# FIRE RISK ASSESSMENT

## **Charleton House** **St Jude's, Great Ann Street, Bristol, BS2 0DS**

CLIENT	Bristol City Council
ASSESSED BY	Bob Birtles Keith Todd
ASSESSED ON	24/07/2024
ASSESSMENT REF.	LS 422354
RECOMMENDED REVIEW DATE	24/07/2025
VERSION	1

LOCATION Flat 16

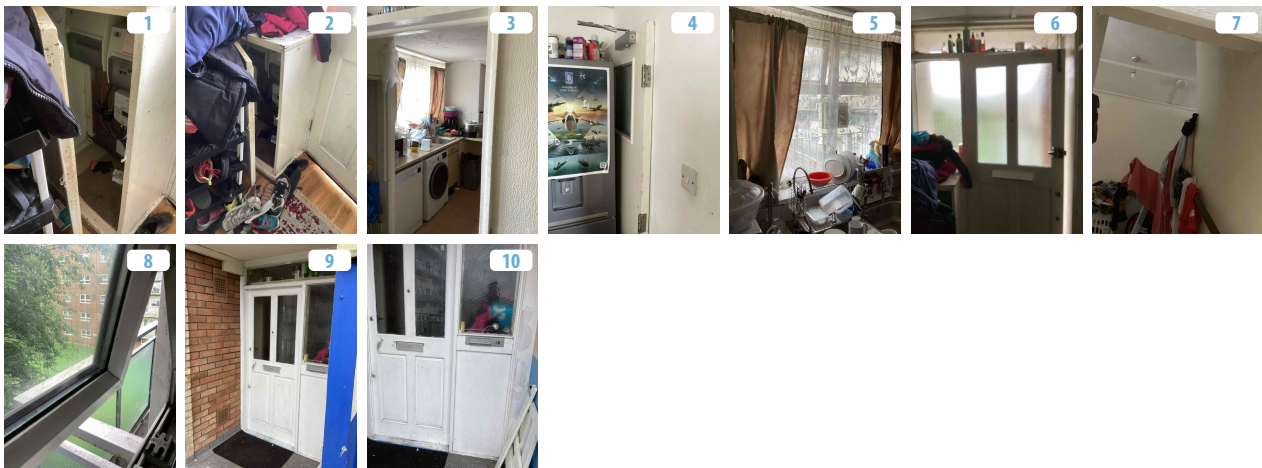
Duplex layout, twin level. Originally designed as a hallway protected layout, although the kitchen door has been removed. (Leaving a notionally protected hallway except for the kitchen, with a mixed standard of internal doors).

Main entrance door is not fire rated, not necessary for deck access with two escape directions.

Fire detection: hardwired, battery back up, BS 5839 Part 6 system, interlinked smoke alarm at entrance hallway and first floor landing. No heat alarm in kitchen.

Advice given regarding the benefits of reinstating the kitchen door.
